MEMORANDUM

REVIEW TYPE: Final Water Quality Plan and Site Plan Review
APPLYING FOR: Approval of 487 dwelling units (153 SFD, 202 TH's and 132 multifamily units) inclusive of 46 MPDU's on 77.61 acres
PROJECT NAME: Clarksburg Town Center Phase II
CASE #: 8-02014
REVIEW BASIS: Sec. 59-D-3, M. C. Zoning Ordinance

Re: Clarksburg Town Center – Site Plan 8-02014 Phase 2

SUBJECT: Clarksburg Town Center, Phase II - Site Plan No. 8-02014

MPDU LOCATION PLAN

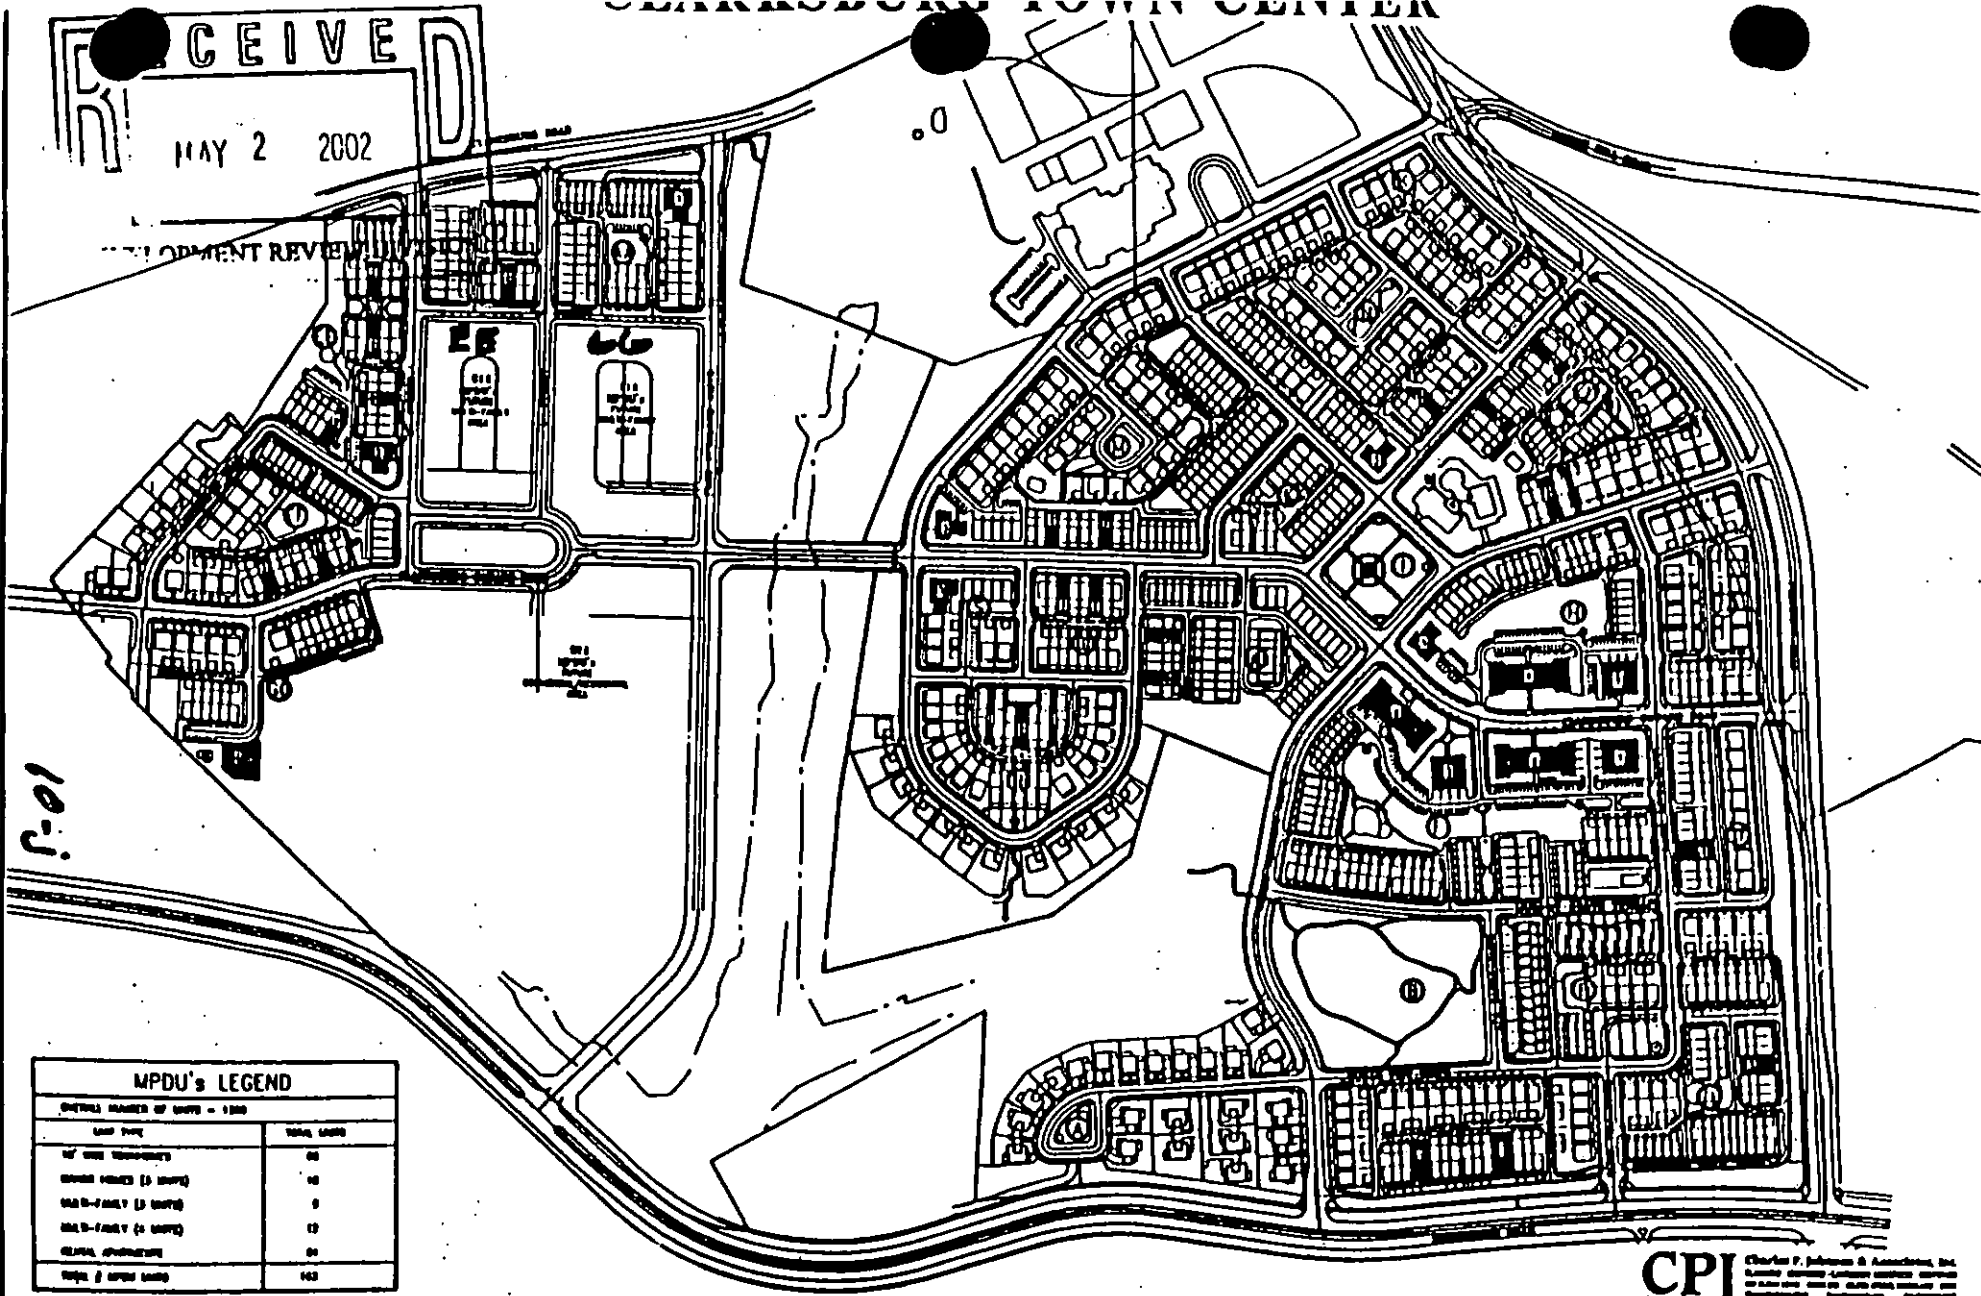
In order to maintain an equitable balance of MPDU's, all units within Blocks EE and GG of Phase I Site Plan 8-98014 as shown in MPDU exhibit dated May 2, 2002 (attached) will not be constructed until the Planning Board approves a revision of those blocks (proposed to be resubmitted for approval).

In order to maintain an equitable balance of MPDU's, all units within Blocks EE and GG of Phase I Site Plan 8-98014 as shown in MPDU exhibit dated May 2, 2002 (attached) will not be constructed until the Planning Board approves a revision of those blocks (proposed to be resubmitted for approval).
